SUNLIGHT HOUSE
LISTED BUILDING CONSENT
CENTRAL OFFICE BULKHEADS

Date: 21/09/2024
Revised: 06/11/2024
Planning Ref: 136161/LO/2023

Office Bulkheads

CENTRAL BULKHEAD

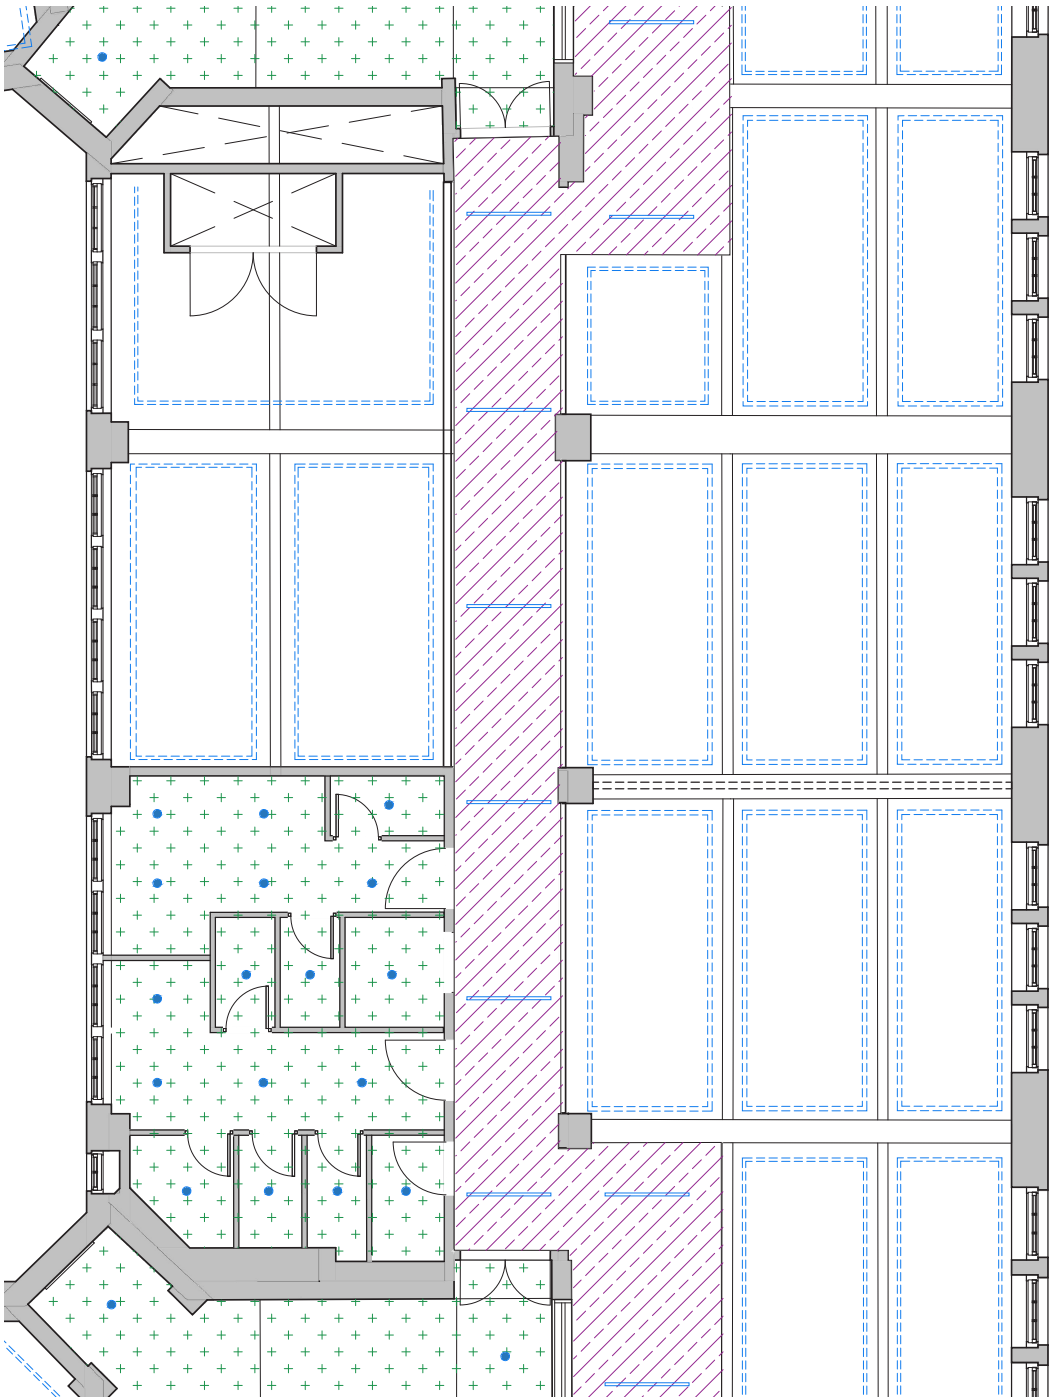
As part of the development of the design there are slight changes to the bulkhead locations from the previously approved.

- REDUCTION:
Bulkhead is reduced in size in front of the South Core entrance.
- EXTENSIONS:
Bulkhead is extended in these locations to avoid exposed services. Please see the next page for explanation.

- CENTRAL BULKHEAD
- EXTENSION

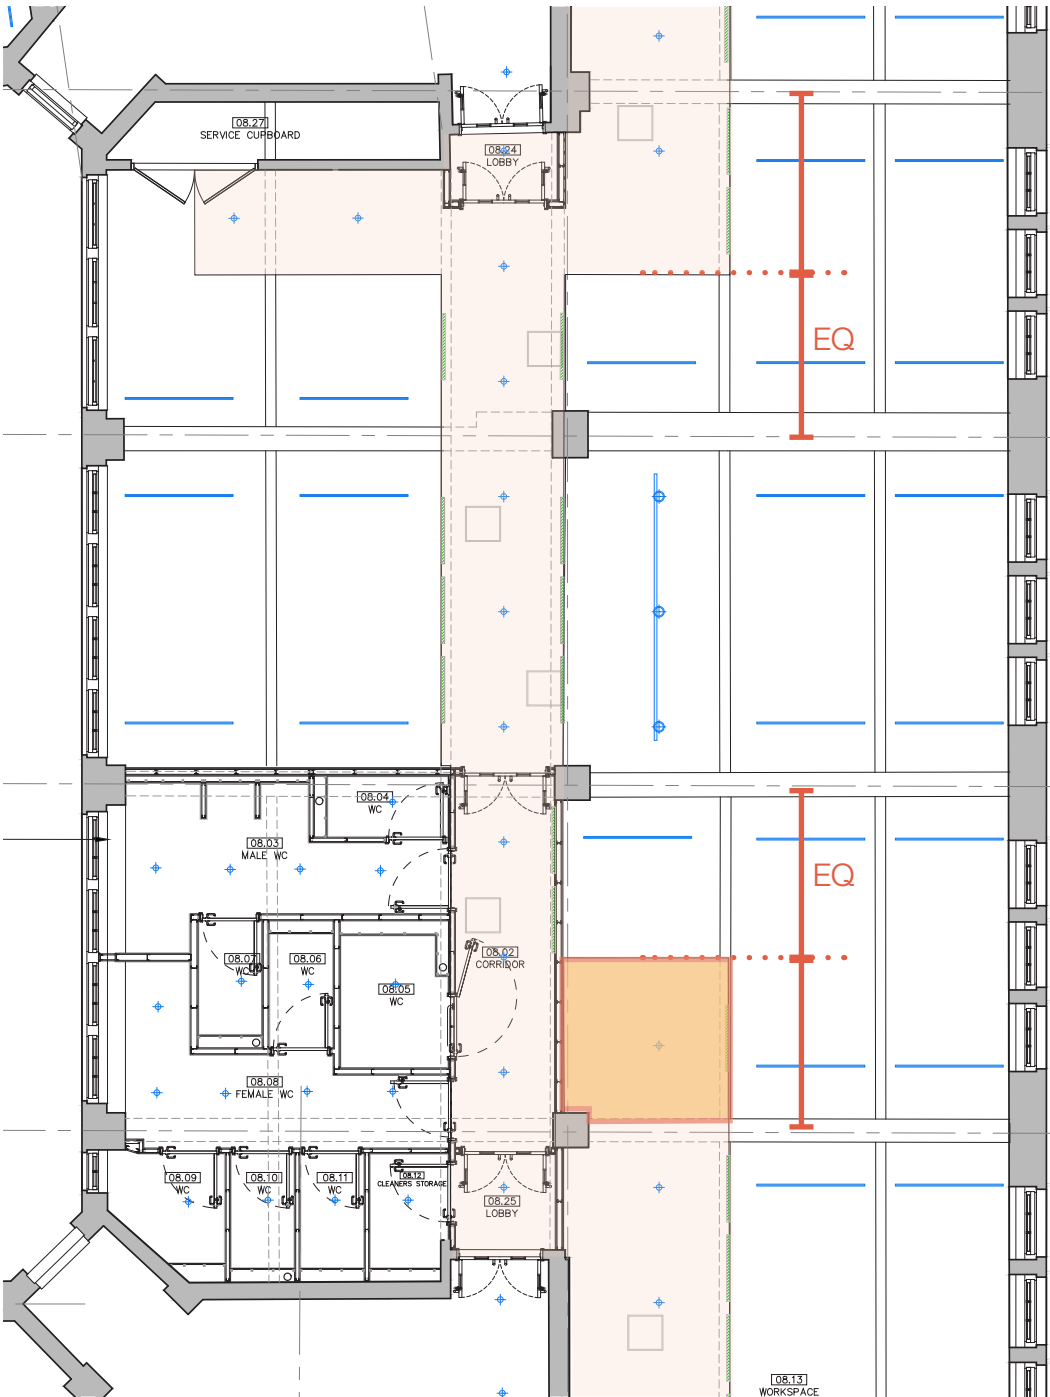
Extension to office space (opposite the WC)

Upon completion of soft strip it became clear that there's an original structural beam and heritage brickwork in this location, as shown on the photo below. The red line denoted the end of the beam which is almost in line with the bulkhead depth.

As a result we're suggesting the bulkhead extension to allow us to go through a new studwork section of wall instead.

The bulkhead extension line will finish in the middle of the coffer. This has been mirrored from the other coffer for a more aestheric and considerate overall look.

- CENTRAL BULKHEAD
- EXTENSION

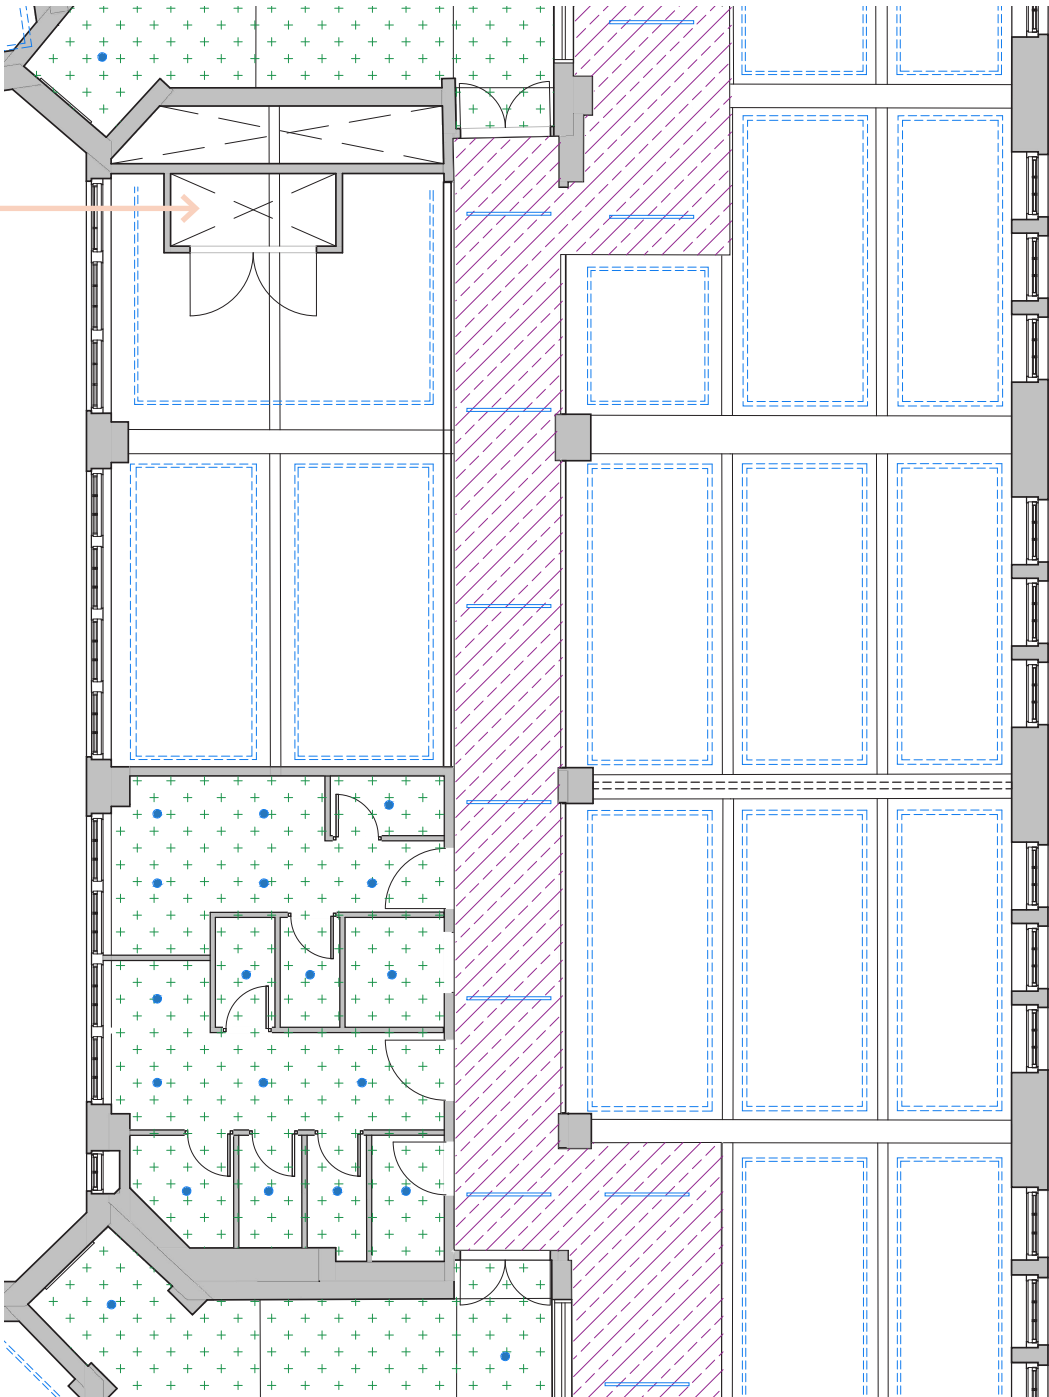
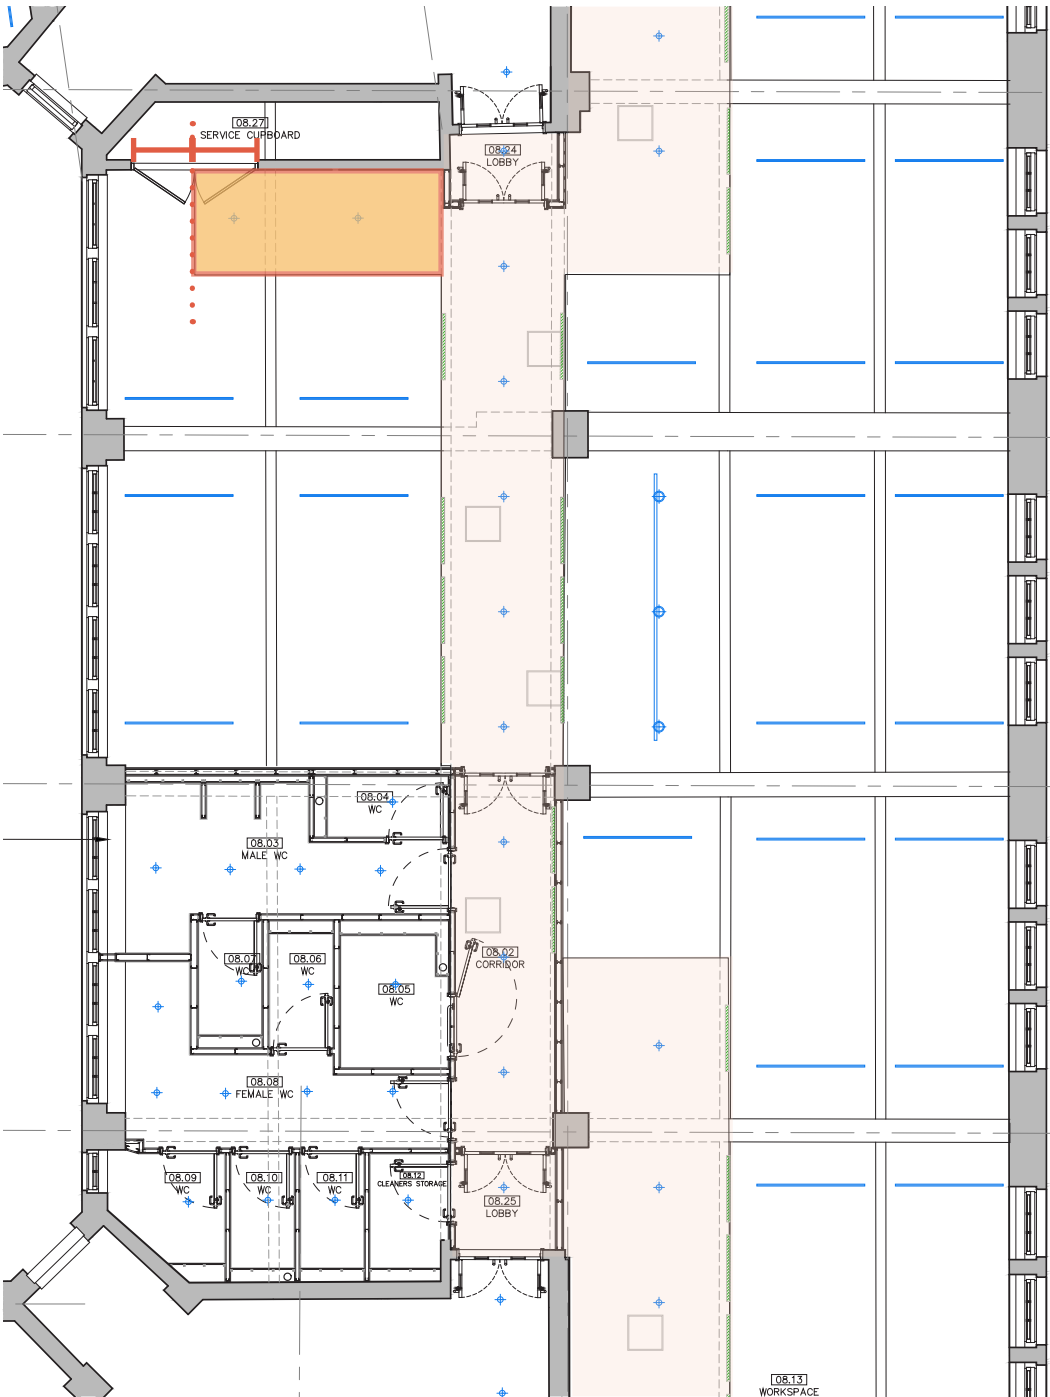
Extension to office space (in front of the riser)

Approved drawing showed the servise cupboard location retained. It is now proposed to ommit this on-floor cupboard.

As a result, services had to be rearranged inside the service riser. The original intention was for the high level penetrations to feed from the riser to the bulkhead to the right of the proposed extension. There is a 1.6m wide vertical tray which goes floor to ceiling on all floors.

Therefore the bulkhead line need to move across to the left to accommodate all the routs. As shown on the photo below the bulkhead will finish in the middle of the new riser double door.

The proposed bulkhead end is around 1500mm offset from the window.

ORIGINAL PROPOSAL

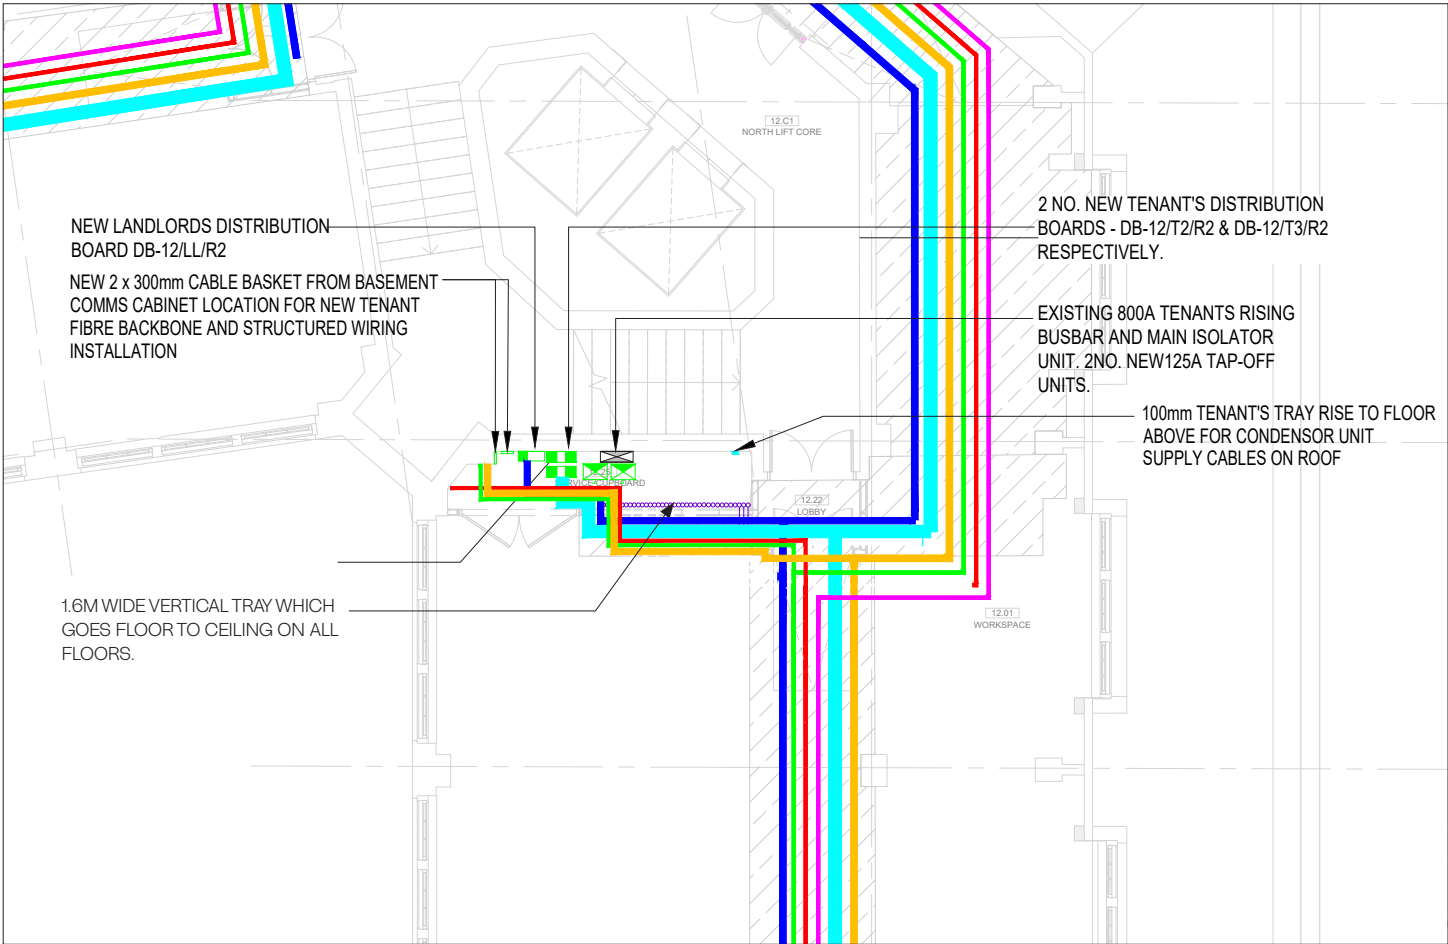
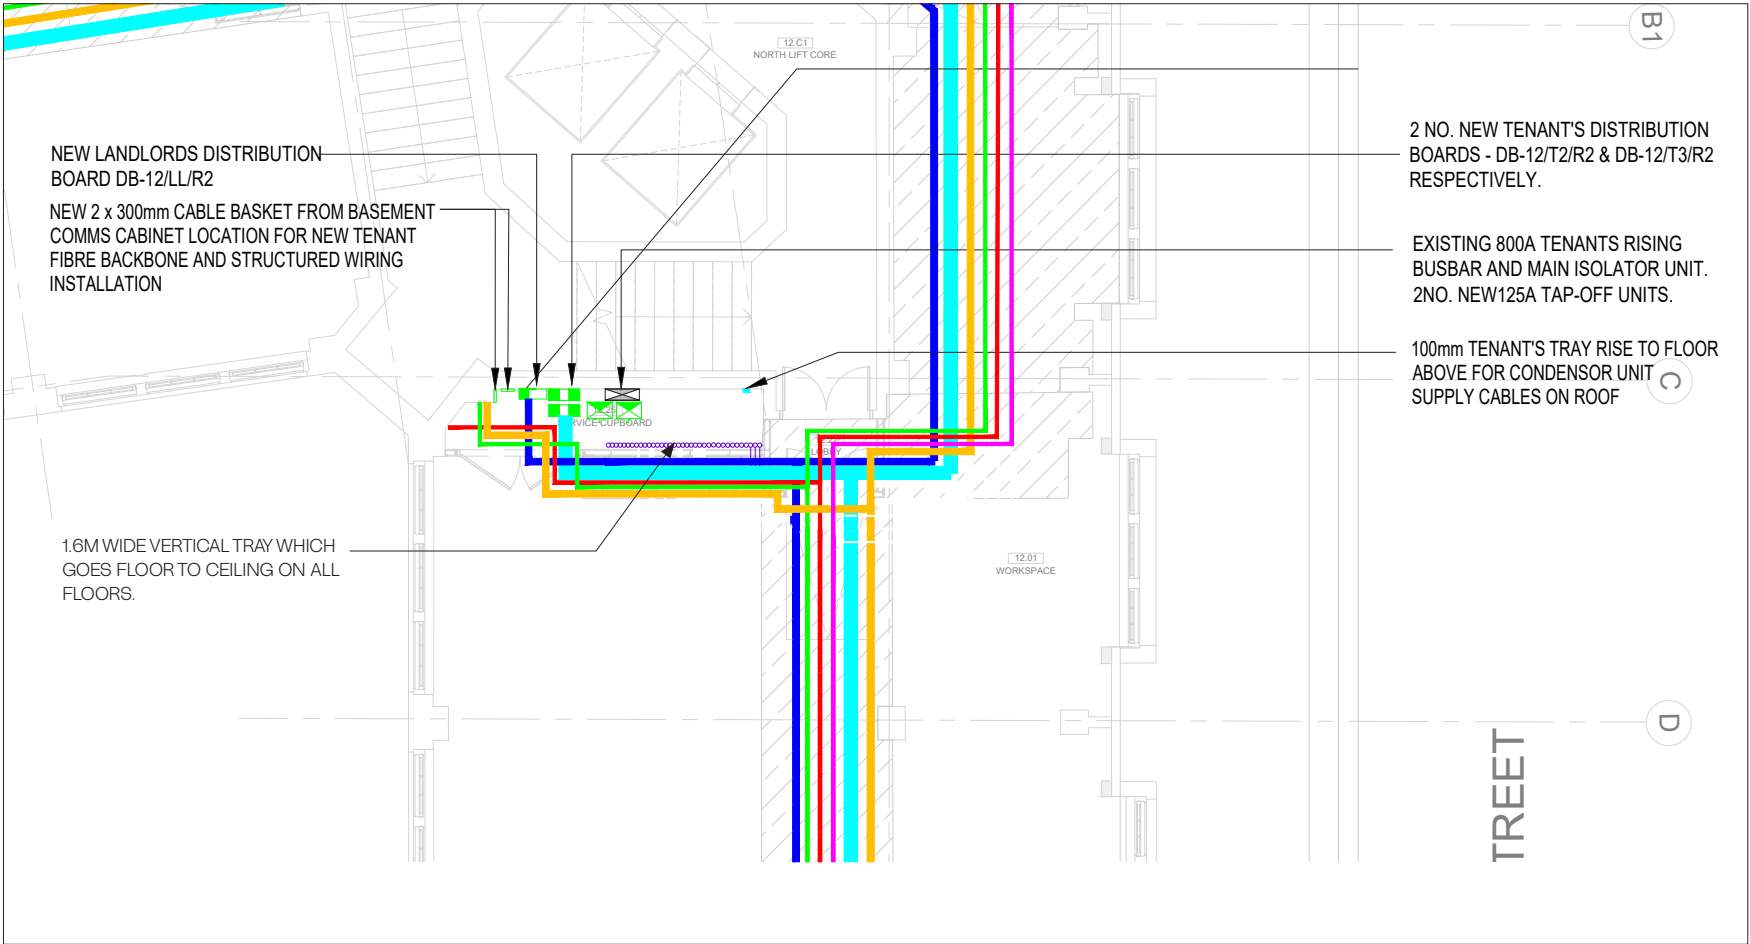
Extension to office space

(in front of the riser)

The original intention was for the high level penetrations to feed from the riser to the bulkhead to the right of the proposed extension. There is a 1.6m wide vertical tray which goes floor to ceiling on all floors.

Therefore the bulkhead line need to move across to the left to accommodate all the routs. And allow access to the distribution boards.

The proposed bulkhead end is around 1500mm offset from the window.
